Technical Data Sheet

Bennington 8350 Side Door Latch Upgrade Kit #93-73508

Publish Date: 3/27/2006

Figure 1: Latch Upgrade Components

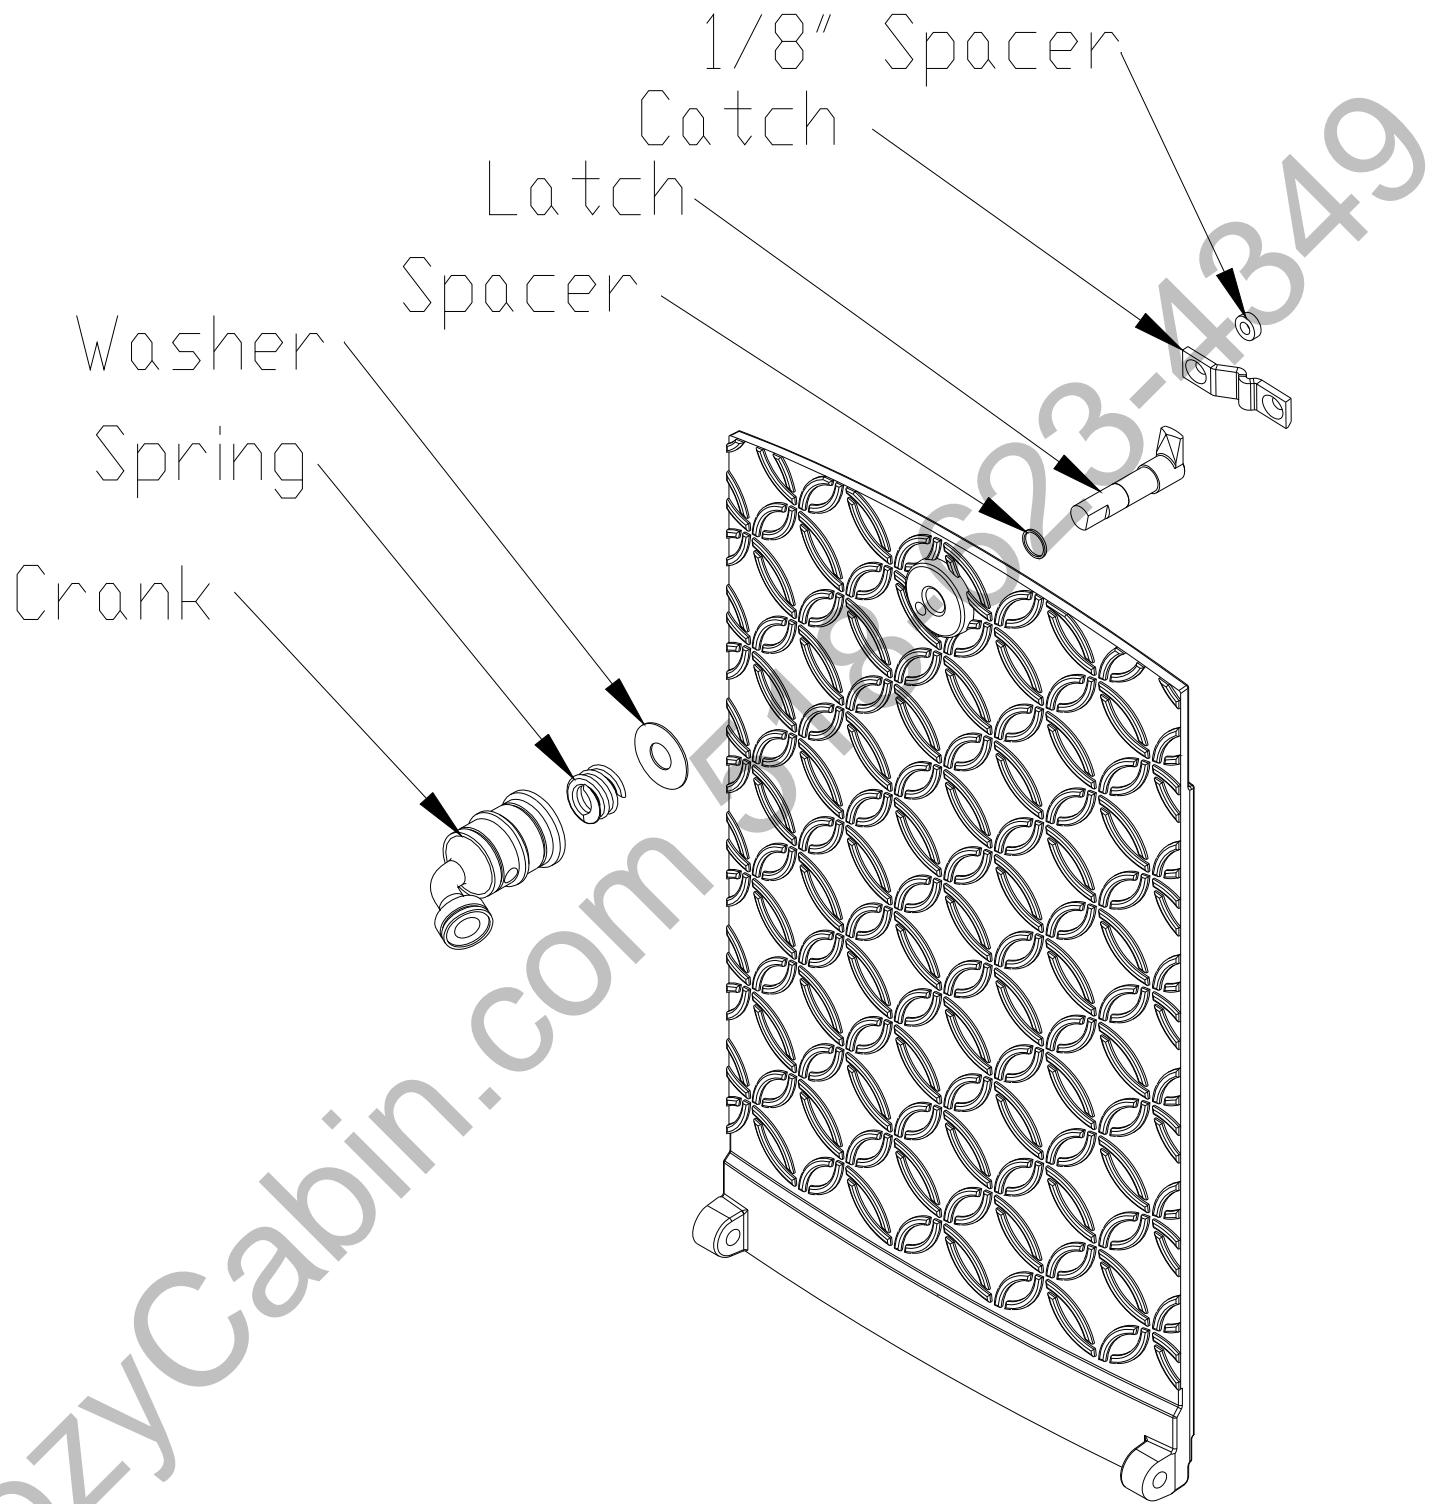
- 1) Remove and discard the side door latch assembly by loosening the two setscrews.
- 2) On models built before September 2005 (serial numbers below 3115), remove and discard the side door catch only by removing the two Phillips head screws.

- 3) Install the new catch using the screws removed in step #2 inserting the 1/8" spacer behind the left side of the catch (as shown on sheet 2).
- 4) Install the new latch assembly as shown on sheet 2. Start out with one brass spacer ring on the latch shaft inside of the door. With the latch shaft extending through the door, place the washer and coil spring on the latch shaft on the outer side of the door. The chrome crank can now be threaded onto the latch. Turn the crank until there is approximately 1/8" between the crank and the washer.

- 5) Align the setscrew hole in the crank with the flat on the latch shaft and insert and tighten the setscrew with the 5/32 hex wrench.
- 6) Check door seals using the "dollar bill test." Shut the door on a dollar bill. If the bill pulls out without any resistance, then your stove's door isn't sealed properly. Spacers can be added or removed to adjust pressure on the gasket.
